# P1 DROPPER SERUM BOTTLE - OWNER VISUAL REVIEW BOARD (V3)

V3 REVISION - V1 + V2 owner-rejected (shoulder + material); V1/V2 preserved | owner approval: PENDING_VISUAL_REVIEW | GATE_2: BLOCKED | manufacturing authority: NOT_ESTABLISHED
sections: OWNER PHOTOGRAPHY | OWNER-MEASURED DIMENSIONS | OWNER-CONFIRMED MATERIALS | ONLINE-ANALOGOUS EVIDENCE | CALCULATED | VISUALLY ESTIMATED | NEUTRAL GEOMETRY | MATERIAL VALIDATION | VISUALIZATION-ONLY INNER GLASS | OMITTED DETAILS
photographs are perspective + uncalibrated - NO calibrated overlay accuracy claimed | THREAD_GEOMETRY_NOT_MODELLED | masks = unlit alpha authority (never thresholded shaded RGB)

shoulder profile diagnostic (V1/V2/V3 + control points)

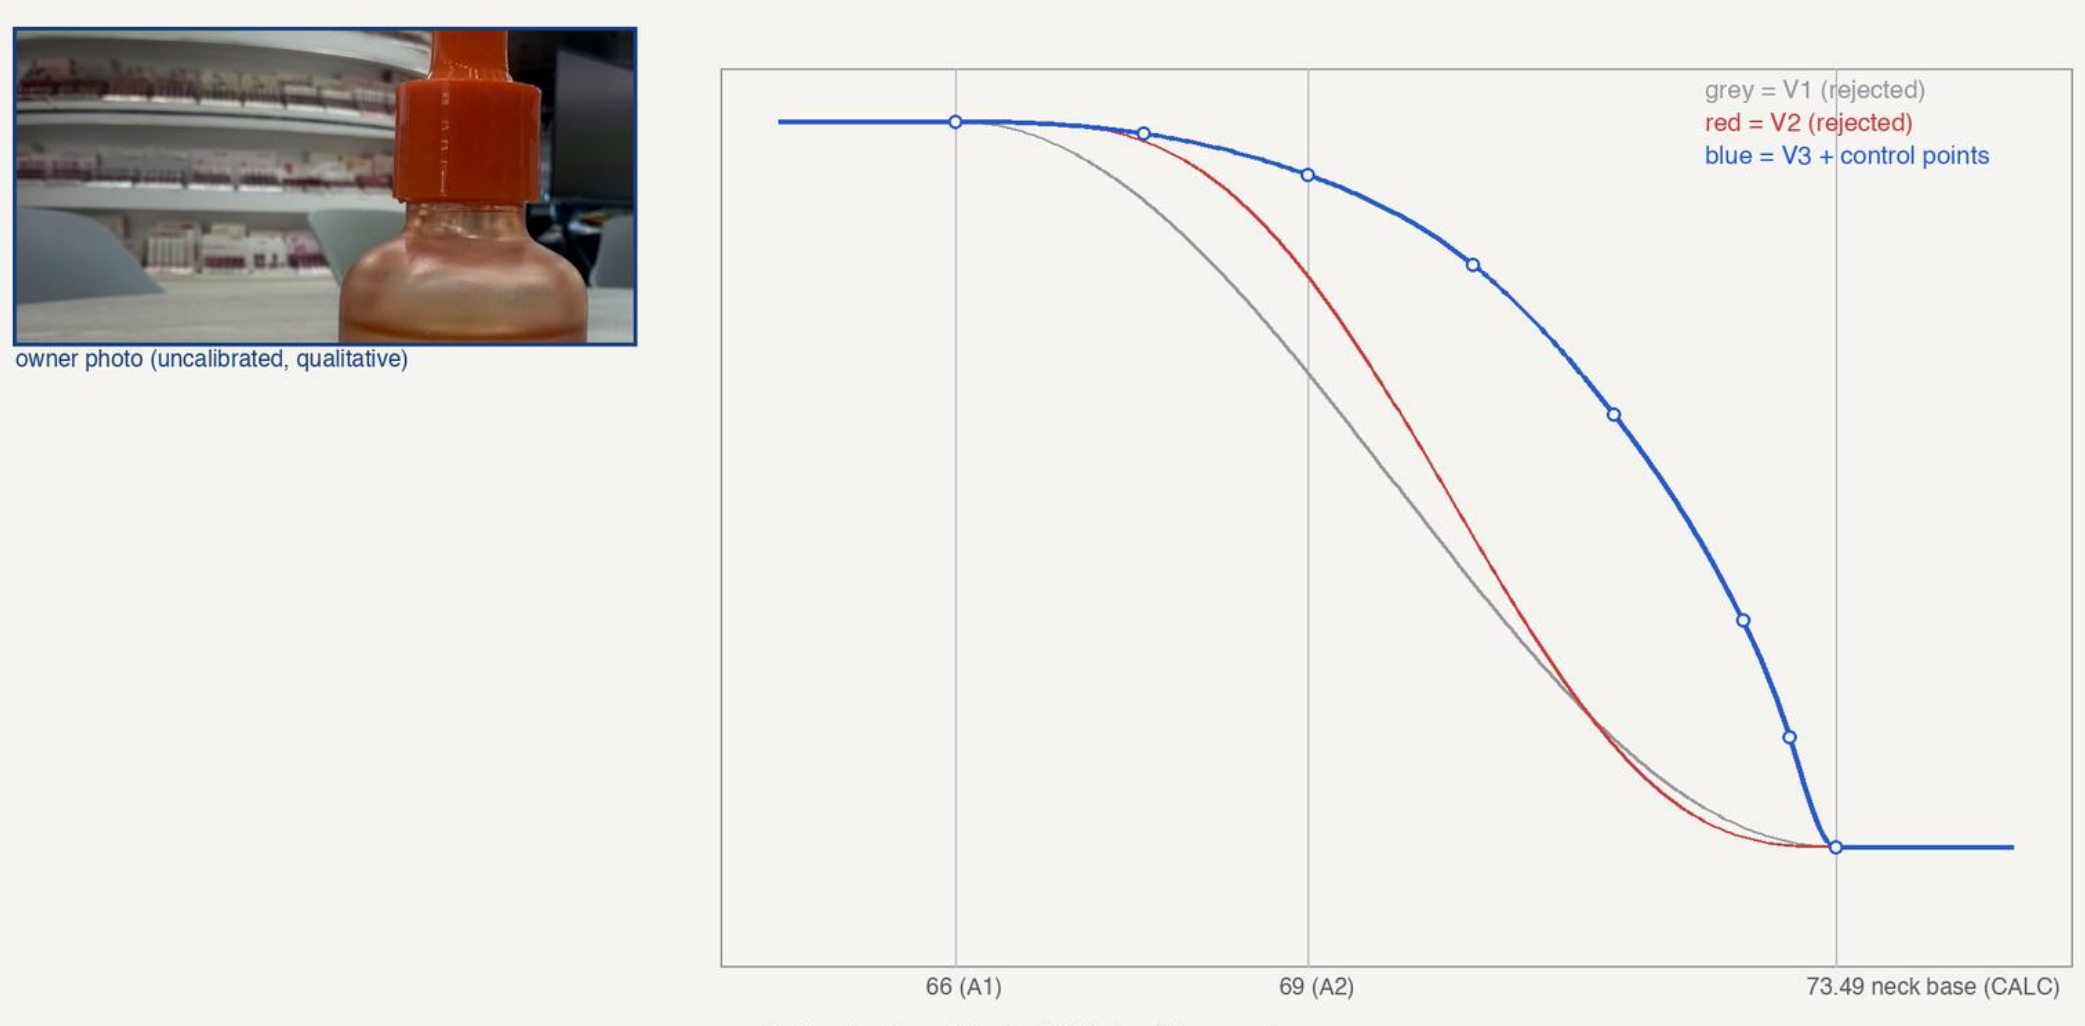
V1 + V2 owner-rejected; V3 = authored clamped cubic spline through VISUAL_ESTIMATE_FROM_OWNER_PHOTO control points (LOW/MEDIUM) - NOT_MANUFACTURING_AUTHORITATIVE

continuity at authored knots (V3, finite differences):
z= 66.00 r= 18.70 dr/dz= -0.000 d2r/dz2= -0.05
z= 69.00 r= 17.90 dr/dz= -0.633 d2r/dz2= -0.29
z= 71.60 r= 14.30 dr/dz= -2.272 d2r/dz2= -0.58
z= 73.10 r= 9.45 dr/dz= -5.562 d2r/dz2= -7.58
z= 73.49 r= 7.80 dr/dz= -0.179 d2r/dz2= 17.89
clamped tangents: dr/dz = 0 at the wall (66) and at the neck base (73.49) - no ridge, no kink

V1/V2/V3 silhouettes - deterministic mask authority

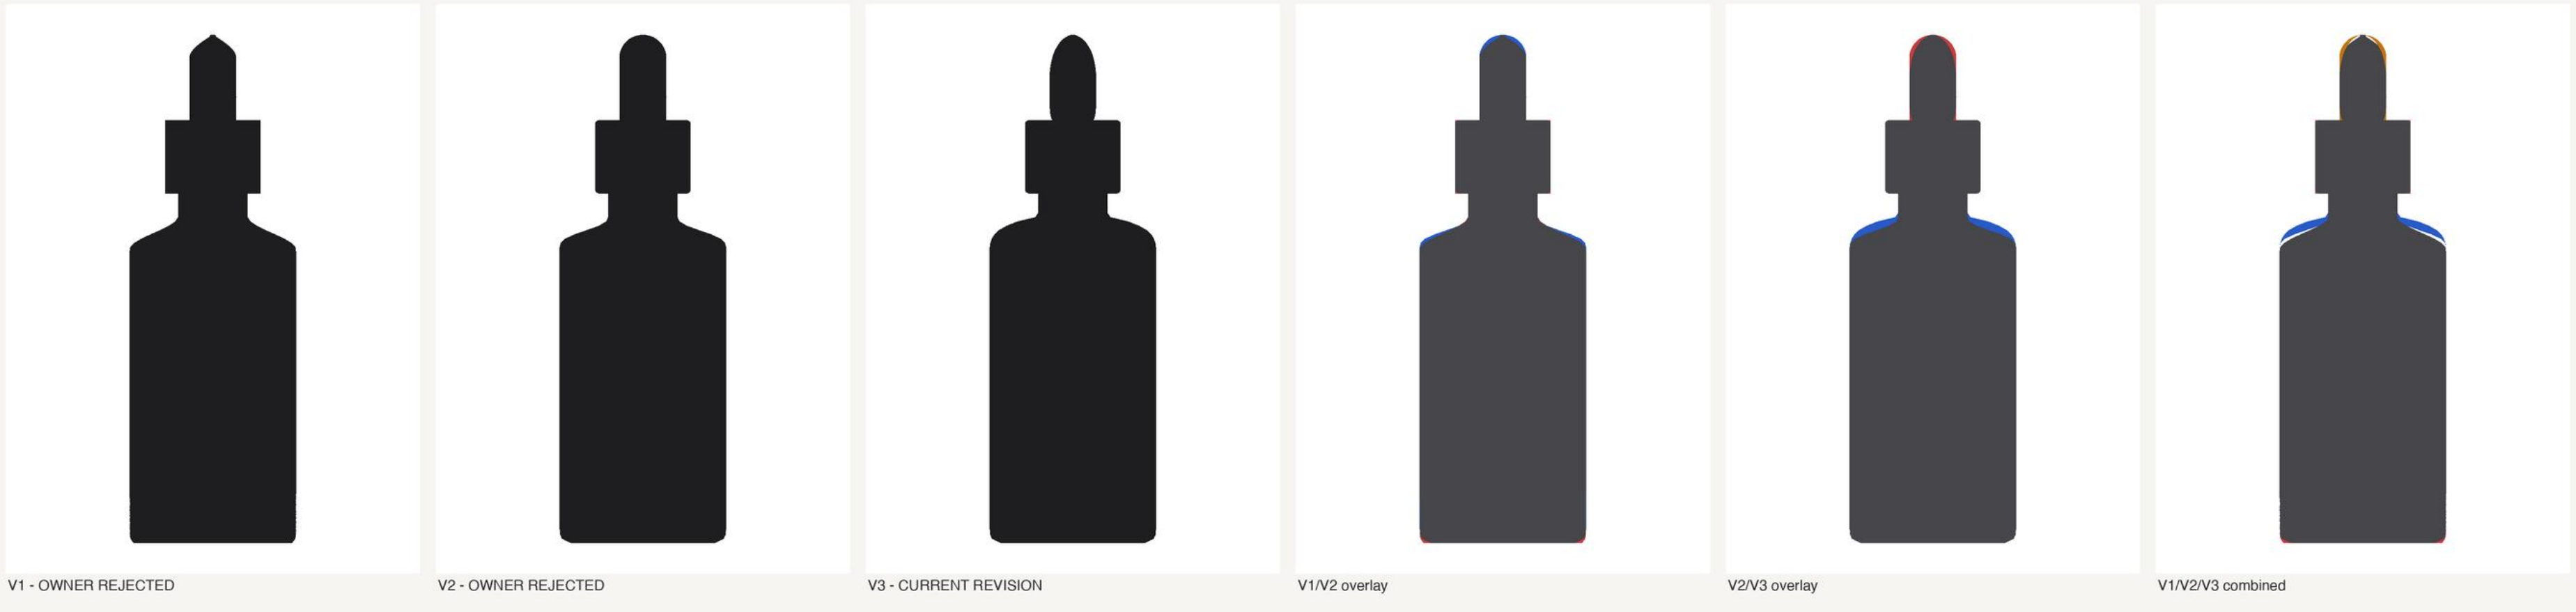
changed: shoulder region (fuller V3 curve) + bulb (V3 narrowed collar entry, fuller dome) | unchanged: body wall, base, collar bounds, all accepted owner dimensions | combined: red=V1-only, amber=V2-only, blue=V3-only, dark=common

V2 vs V3 shoulder close-up

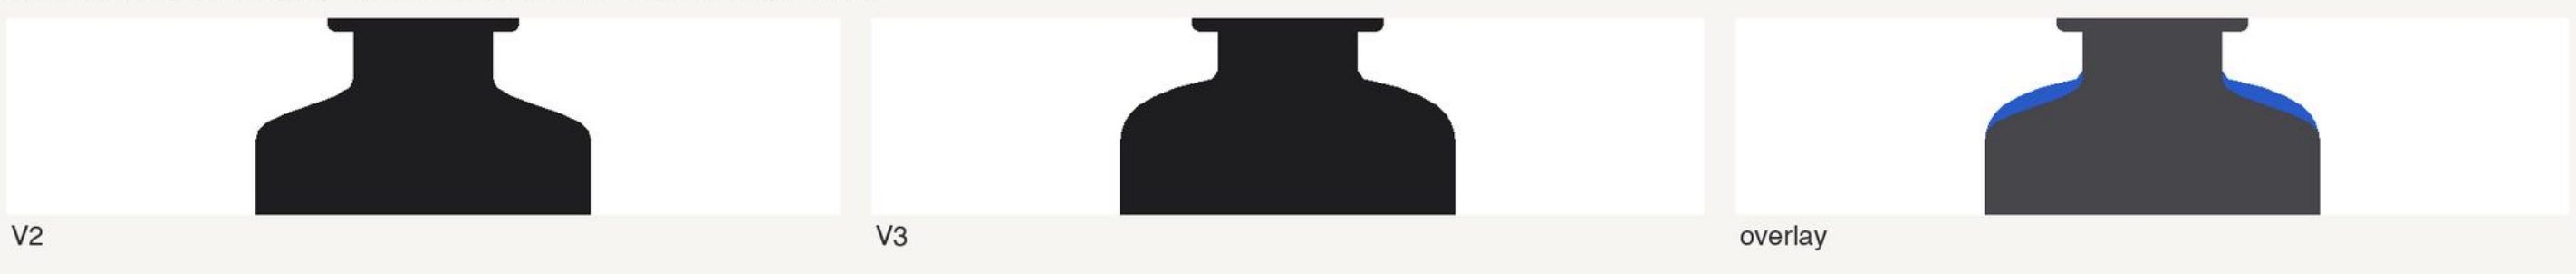
mask authority (unlit alpha) | red=V2 only, blue=V3 only, dark=agreement

V2 vs V3 bulb close-up

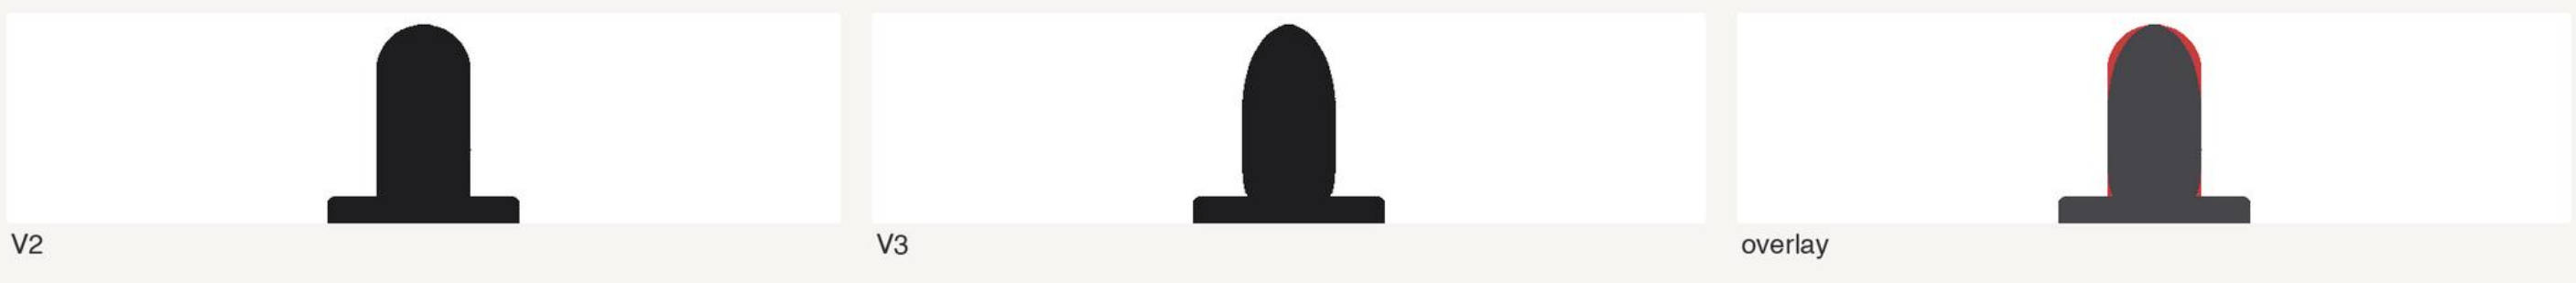
mask authority (unlit alpha) | red=V2 only, blue=V3 only, dark=agreement
